## ***Interactive comment on “Lituya Bay 1958 Tsunami – detailed pre-event bathymetry reconstruction and 3D-numerical modelling utilizing the CFD software Flow-3D” by Andrea Franco et al.***

Received and published: 11 December 2019

The present authors' comment, referring to the discussion paper titled “Lituya Bay 1958 Tsunami – detailed pre-event bathymetry reconstruction and 3D-numerical modelling utilizing the CFD software Flow-3D”, is aimed at the comment of anonymous referee #1, published on 11 November 2019.

**Fig. 1.** Simulation of wave generation and propagation in the entire bay – comparison of simulation results in terms of inundation areas for different roughness conditions; red line: observed trimline; blue ar

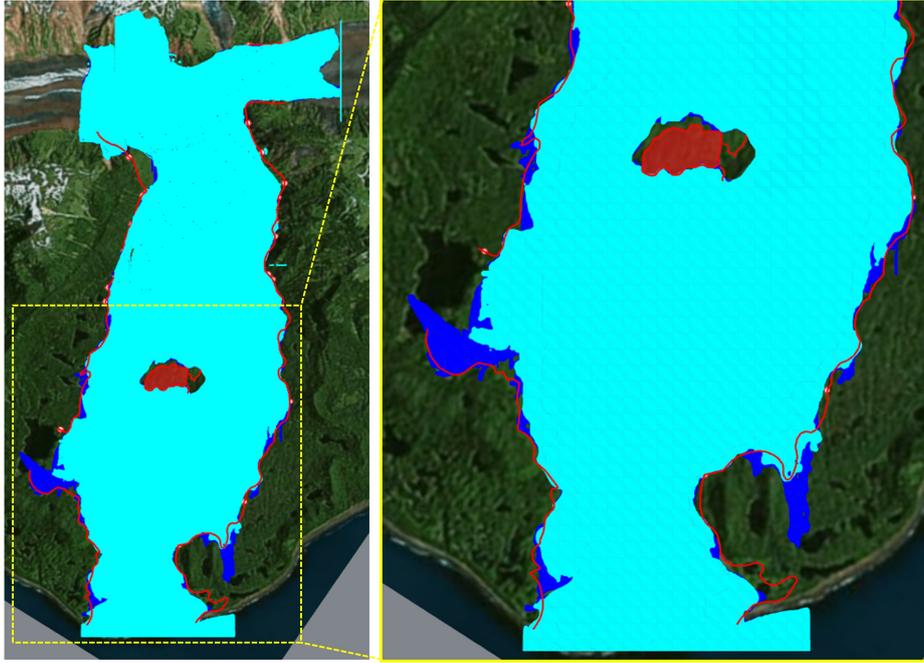
(8) Referee: In p17, l3-8, authors discuss that they don't find differences nor in inundation neither in the trimline with different roughness values from 0-3m. I can understand these results around steeper areas, but are there no differences in the Fish Lake area? What about around the Eastern flat area around the Paps? I cannot understand how the model doesn't provide larger inundation areas around flat areas when the roughness values go to zero.

Authors: We thank you very much for this important note. Discussion of your comment and re-analysis of our models set-up and results finally led to the fact that we could identify a (user) mistake in the parameterization of the roughness in Flow-3D. We will fully consider this during the revision procedure and update the results of the analyses of different values for roughness on inundation. Concerning this aspect reference is made also to the authors comment on the review of referee#2 (issue (18)). Having a look to some first outputs of further simulations with a correct setting for the roughness parameterization, we can appreciate better results and also identify the influence of the roughness value. As an example the attached figure 1 shows the difference in inundation area resulting from two simulations of the entire bay with two different values of the equivalent grain roughness. These simulations are related to the coarsest grid resolution of 20 m uniform cell size.

Based on these simulations and further with finer mesh grid resolution we will revise the analysis and discussion of the influence of roughness accordingly.
